Planning & Highways Committee

Response to Langley Sustainable Urban Extension Planning application

Agenda Item 61

DETAILED COMMENTS**Detailed Comments****Appendix A**

Western Boundary
Springfield Road

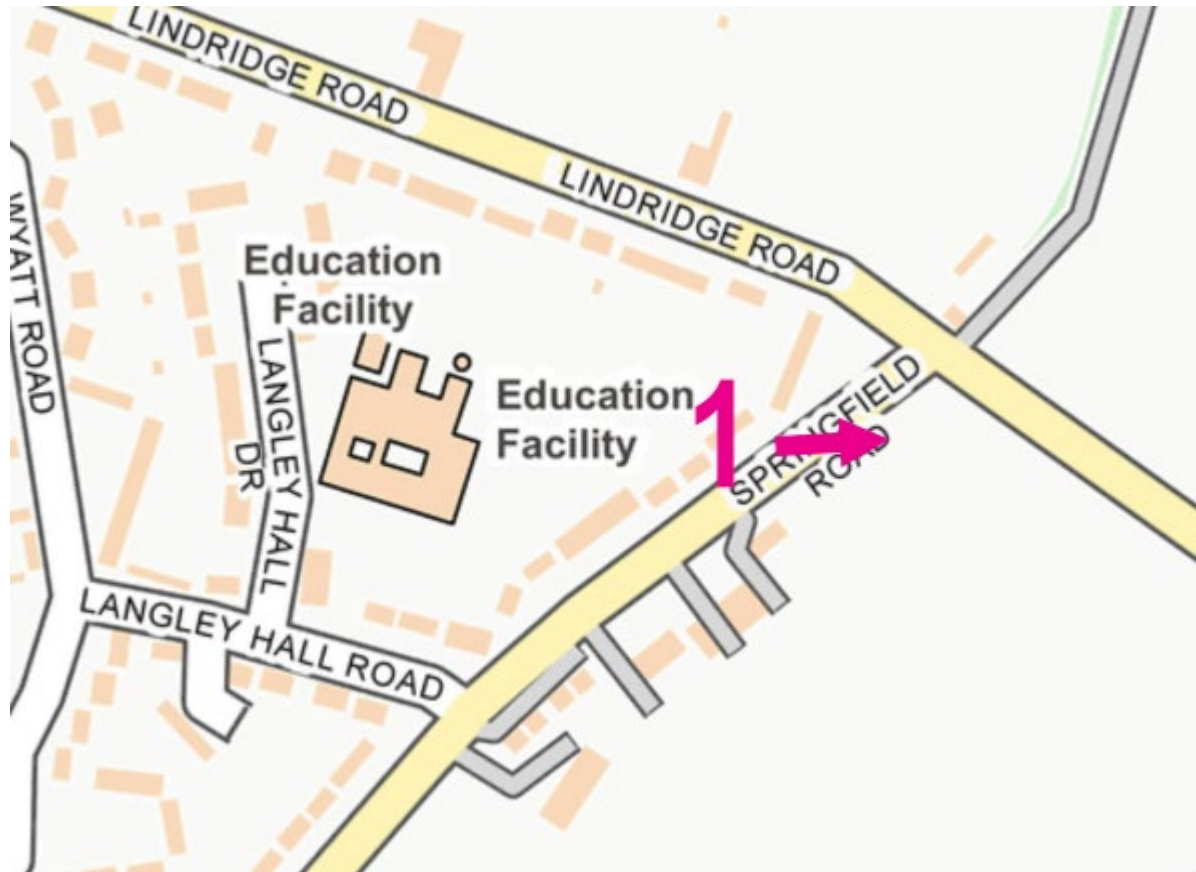
1: AIA Sheet 1 and LGA drawing edp7372_d100h. For some reason, an existing strip of hedgerow at this point on Springfield Road appears not to be shown on the AIA or the LGA. We would encourage the applicants to retain it.

See point 1 under detailed comments

Existing strip of hedgerow

Western Boundary
Springfield Road

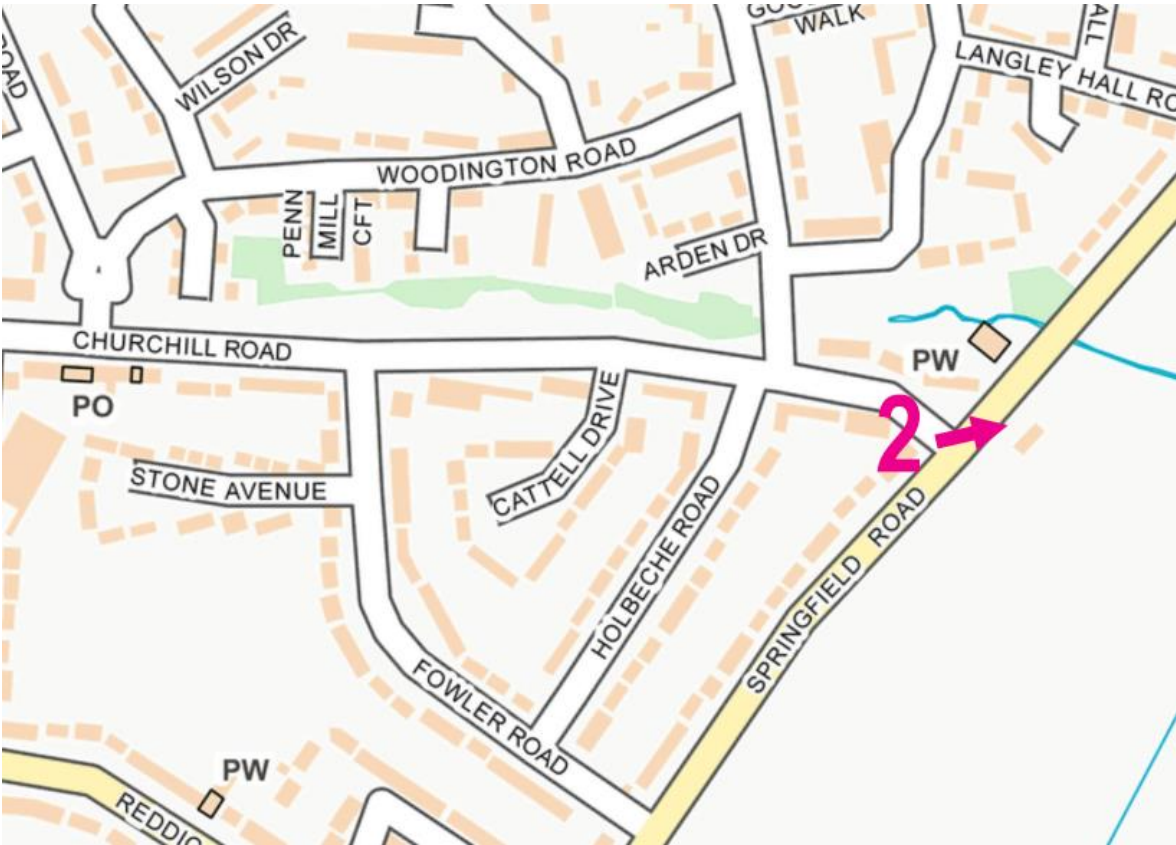
2: AIA Sheet 1 and LGA drawing edp7372_d100h. It appears that a considerable length of hedgerow at this point on Springfield Road will be removed in order to form a new highway junction opposite Churchill Rd. Although required visibilities splays may be the cause of much of it, it appears that the position of the cycleway is also an important element. We would suggest that other locations for this facility - potentially behind the hedgerow - should be investigated. Around the retained houses and, near to the figure 2 on the drawing, there is a hedgerow and a group of trees which does not seem to be shown on the AIA or the LGA for some reason. Again, this should be investigated as much of it could be retained.

See point 2 under detailed comments

Existing trees and hedge

Proposed cycle way could be located behind the hedgerow

Western Boundary
Springfield Road

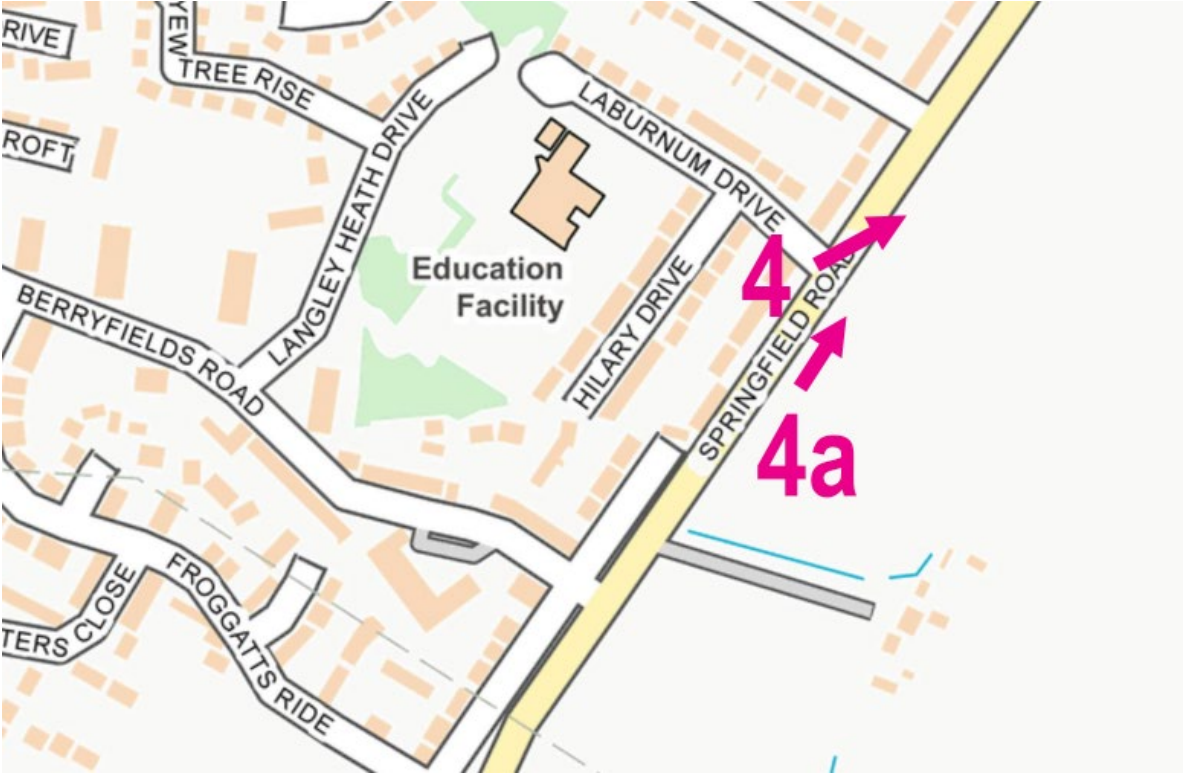
3: AIA Sheet 3 and LGA drawing edp7372_d102d. A substantial length of hedgerow at this point on Springfield Road is shown as being removed and replaced almost immediately adjacent to it. The apparent reason for this is, again, the creation of a cycleway along the existing verge. Although the cycleway itself is to be welcomed we would suggest that the relocation of it behind the hedge should be considered. This is also an example of where any new hedging should be supplemented by hedgerow trees.

3a: Passive supervision of a cycleway or pavement located behind the hedgerow would be important, but the coloured plan, taken from the Outline Planning Application, shows that the first phases of house building – shown red - will be on the western side of the site and could therefore be designed to overlook any cycleway or pavement.

See point 3 under detailed comments

Proposed cycle way could be located behind the retained hedgerow and trees added

See point 3a under detailed comments

Western Boundary
Springfield Road

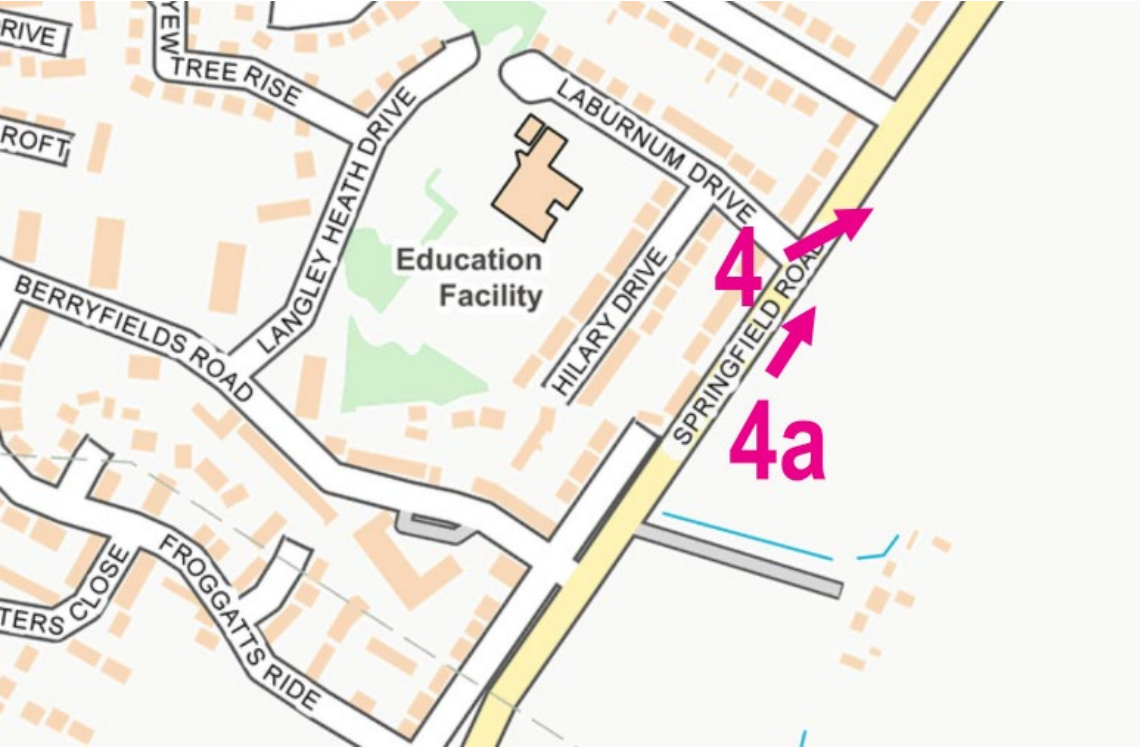
4: AIA Sheet 6 and LGA drawing edp7372_d105f. It is to be welcomed that there is a long run of retained hedgerow at this point on Springfield Road. If the applicant has not taken the opportunity to insert hedgerow trees due to the overhead cables, would they consider relocating the services in order to permit this welcome improvement?

See point 4 under detailed comments

Overhead cables

Western Boundary
Springfield Road

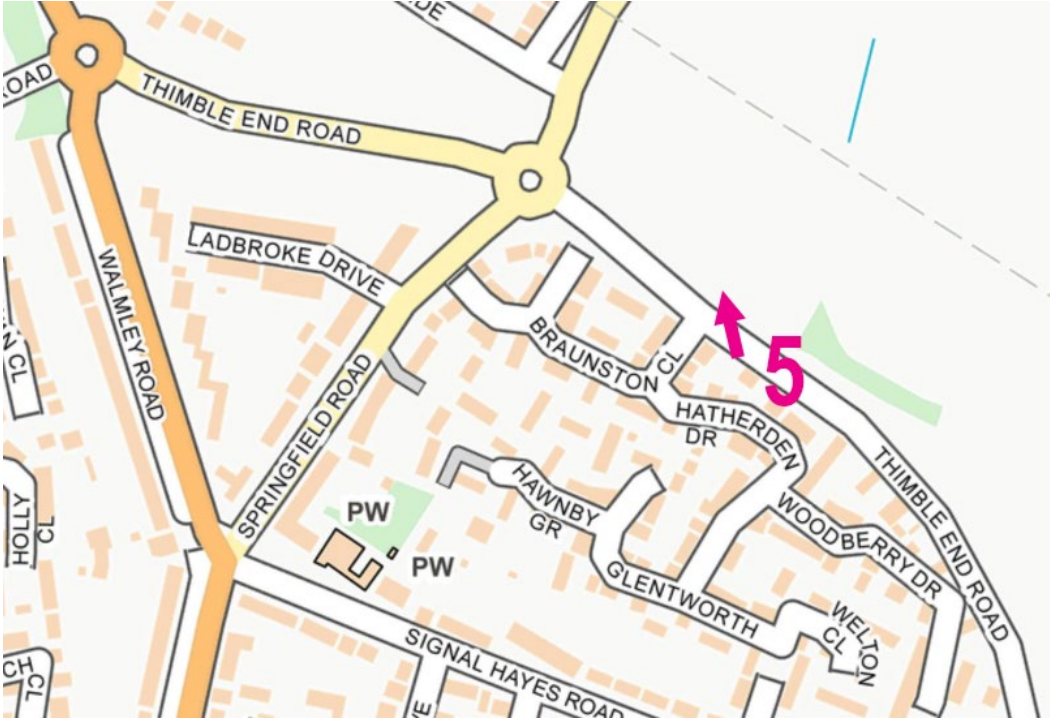
4a: Interestingly, the verge seems to be less than 2m wide in places, and the applicants appear to be proposing the insertion of a pavement/cycleway. Is this feasible?

See point 4a under detailed comments

Verge measuring approx. 1.5m in places

Western Boundary
Thimble End Road

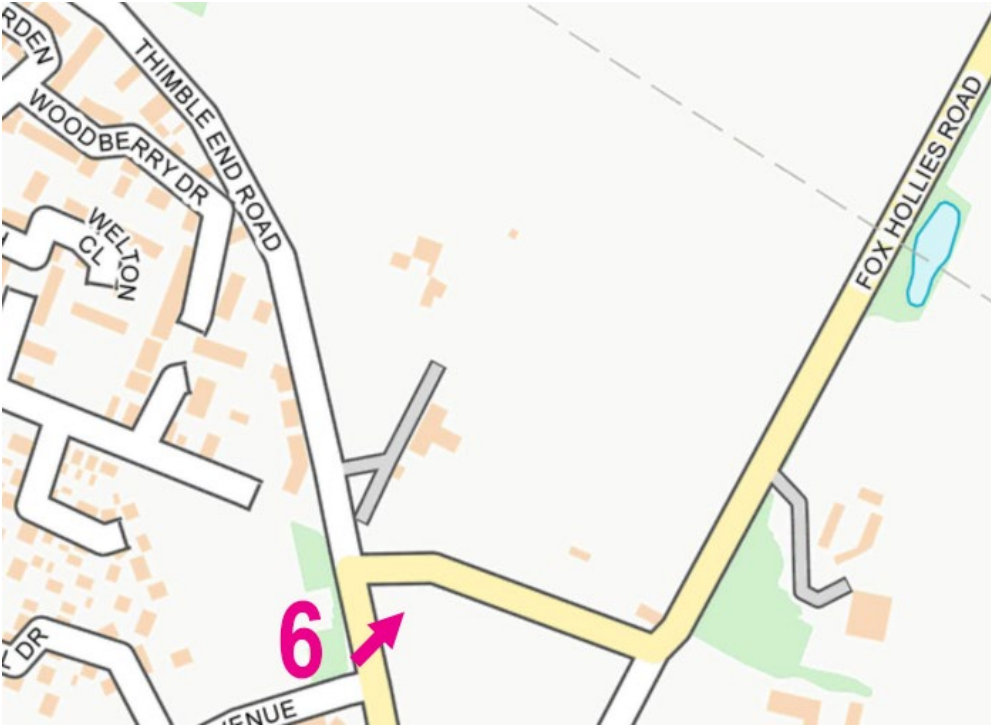
5: AIA Sheet 12 and LGA drawing edp7372_d111e. These drawings appear to indicate that a number of existing trees are to be replaced at this point on Thimble End Road - apparently in order to permit the insertion of a pavement/cycleway - although the hedge behind them is to be retained. The photograph of the site shows that the existing trees are, in fact, either within the hedgerow or immediately adjacent to it and that, therefore, no new trees could be any more discreetly placed. We wonder if, perhaps, the arboricultural survey does not show the correct location of the trees?

See point 5 under detailed comments

Existing trees and hedgerow

Western Boundary
Thimble End Road

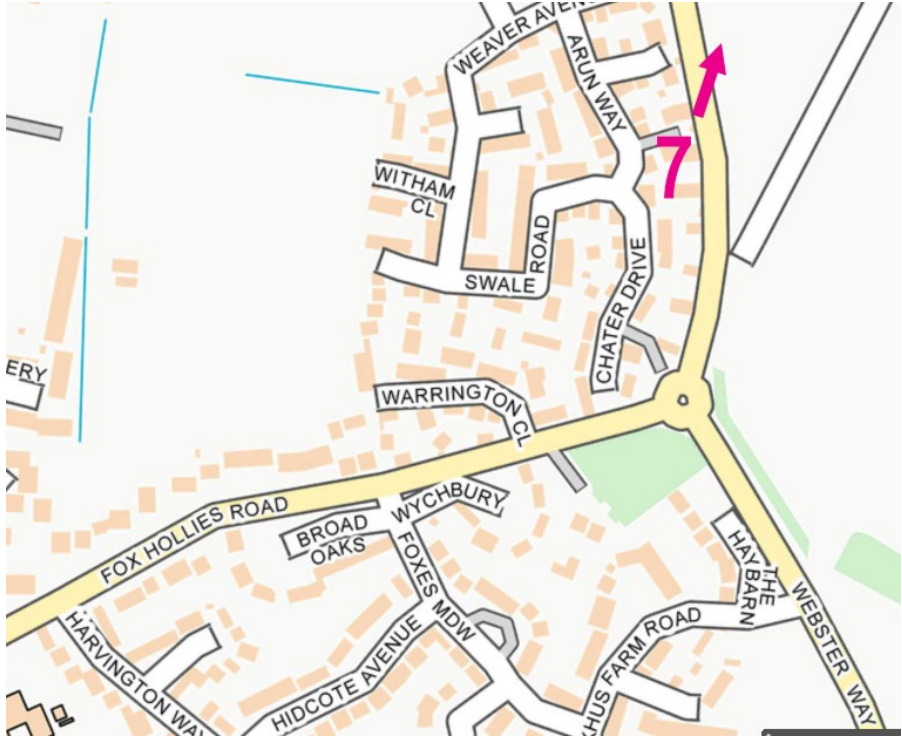
6: AIA Sheet 15 and LGA drawing edp7372_d114e. Although not shown in the AIA, there does appear to be a section of tall shrubs and trees at this point on Thimble End Road which are to be removed due to the geometry of the proposed road junction and cycleway. This arrangement could be reconsidered.

See point 6 under detailed comments

Existing shrubs and trees not shown on proposals

Western Boundary
Thimble End Road

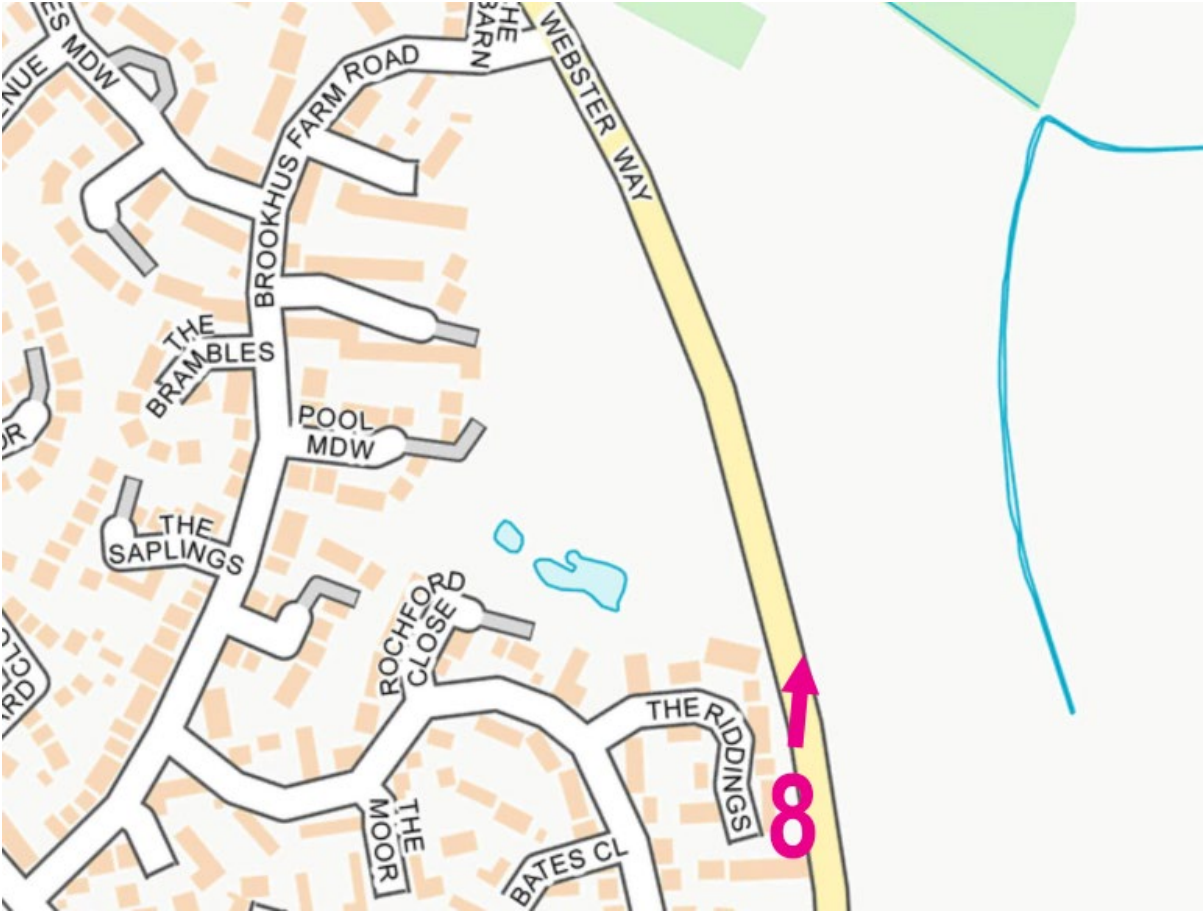
7: AIA Sheet 17 and LGA drawing edp7372_d116d. Although the AIA correctly shows that there is currently a fence, rather than a hedge, along this section of Thimble End Road, we would be interested to know why the developers have not proposed the creation of a hedge with trees. This would considerably improve the character of the area and its ecological benefits. There are also a number of smaller trees which are probably being removed due to the insertion of the pavement/cycleway.

See point 7 under detailed comments

Existing fence

Western Boundary
Webster Way

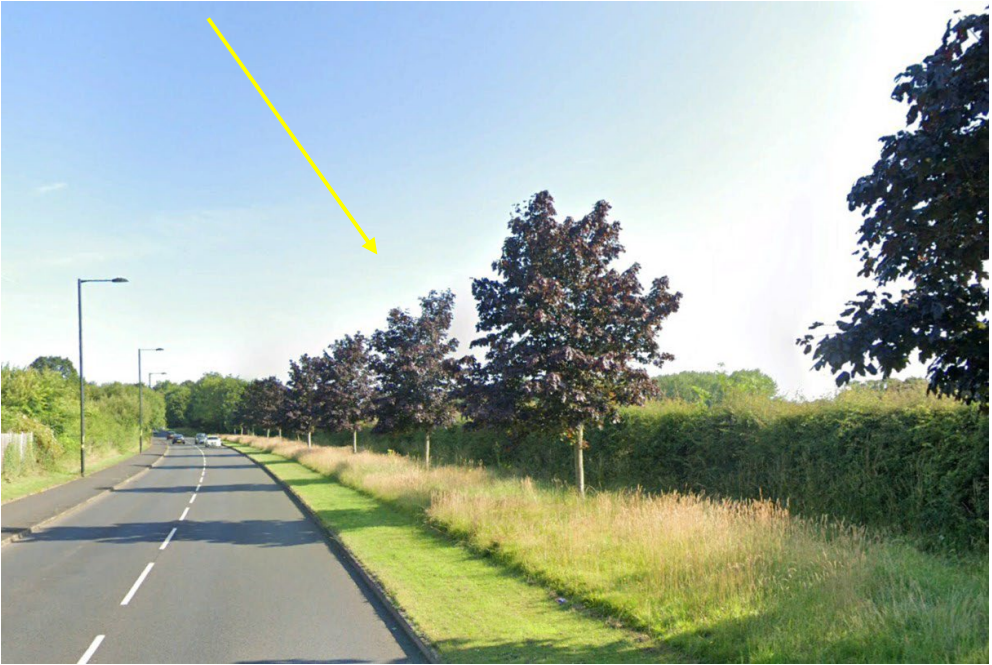
8: AIA Sheet 19 and LGA drawing edp7372_d118f. Although some hedgerow and trees at this point on Webster Way must be removed in order to create new junctions, a larger portion than necessary may have been lost due to the arrangement of the cycleway. An very attractive row of them does not appear to be shown on the AIA. We suggest that alternative arrangements for the cycleway at this point be explored.

See point 8 under detailed comments

Existing shrubs and trees not shown on proposals

Western Boundary
Webster Way

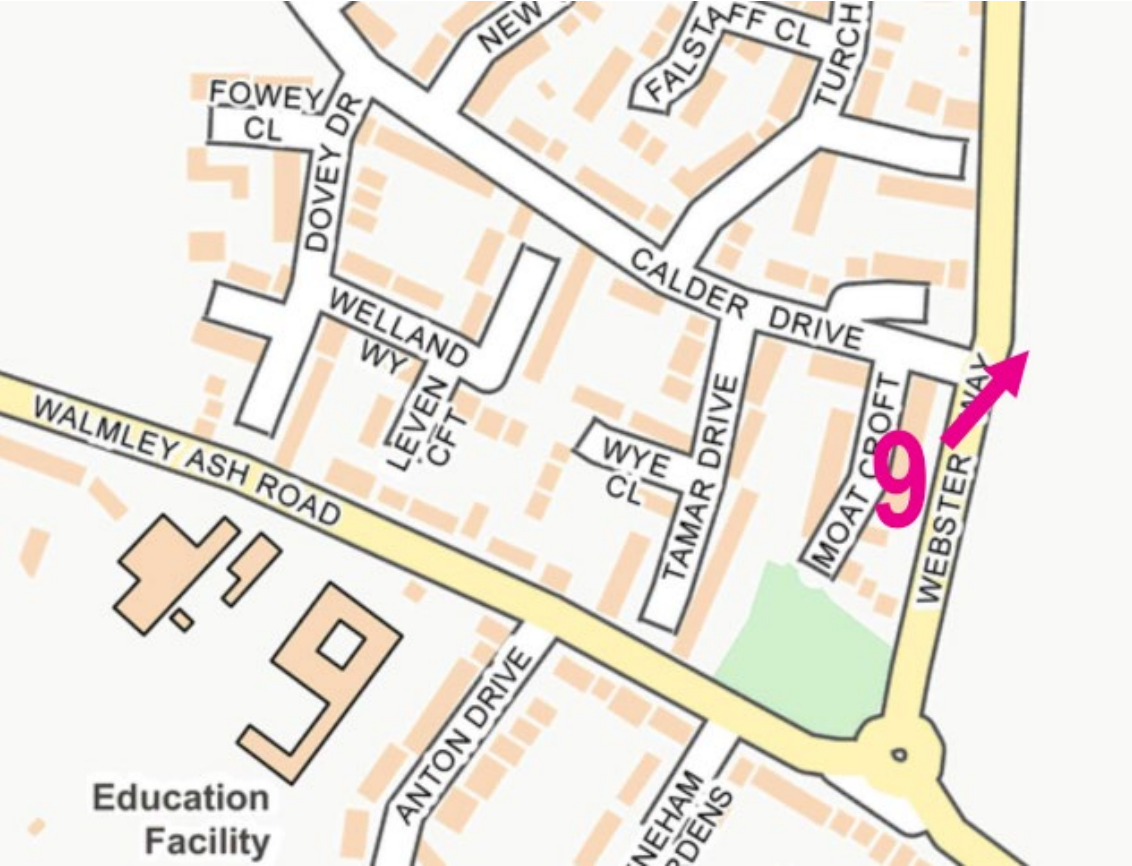
9: AIA Sheet 21 and LGA drawing edp7372_d120d & d121e. Again, the length of hedgerow and the number of trees lost at this point on Webster Way might be reduced if an alternative arrangement for the cycleways could be concluded.

See point 9 under detailed comments

Existing hedgerows and trees

Western Boundary
Walmley Ash Lane

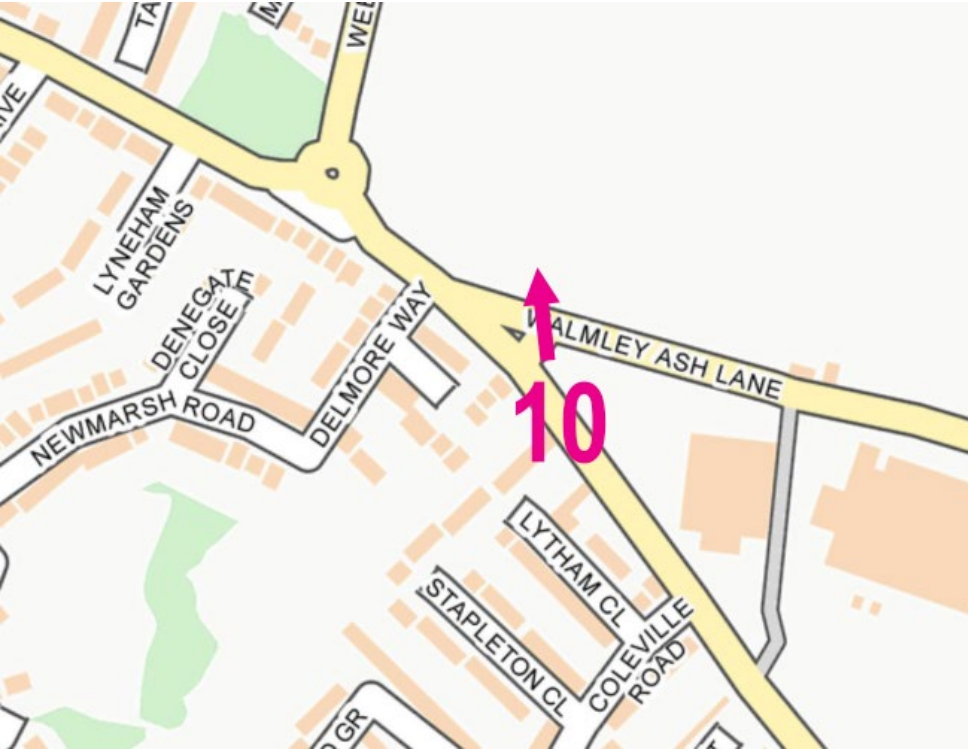
10: AIA Sheet 22 and LGA drawing edp7372_d121e. Here on Walmley Ash Lane, the proposal of a new hedge is to be welcomed, but trees could also be added if the overhead cables were repositioned.

See point 10 under detailed comments

Overhead cables
